Errata Sheet

Product Family:	DL305	Date:	September 2018
Manual Number	D3-ANLG-M		
Revision and Date	3rd Edition, February 2003

Changes to Chapter 3. F3-04ADS 4-Channel Isolated Analog Input

Page 3-3. Setting the Module Jumpers; Jumper Locations

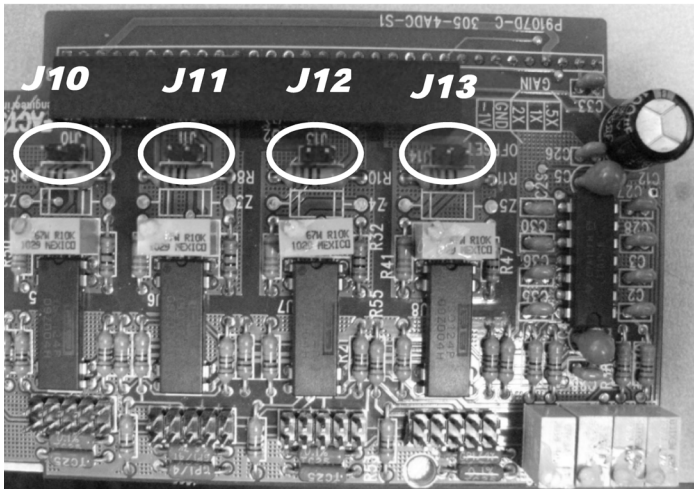
The PC board was redesigned and the locations of jumpers J10, J11, J12, and J13 changed. The jumpers were rotated 90 degrees and are closer to the back of the module than the original layout. The functionality of the jumpers did not change. The orientation of the 5 pairs of pins for each channel is the same.

The photo on the right shows the new design, while the one on the left shows the original PC board. The photo on the left matches the drawing shown on page 3-3. The redesigned PC boards are in modules manufactured starting in mid-2012.0
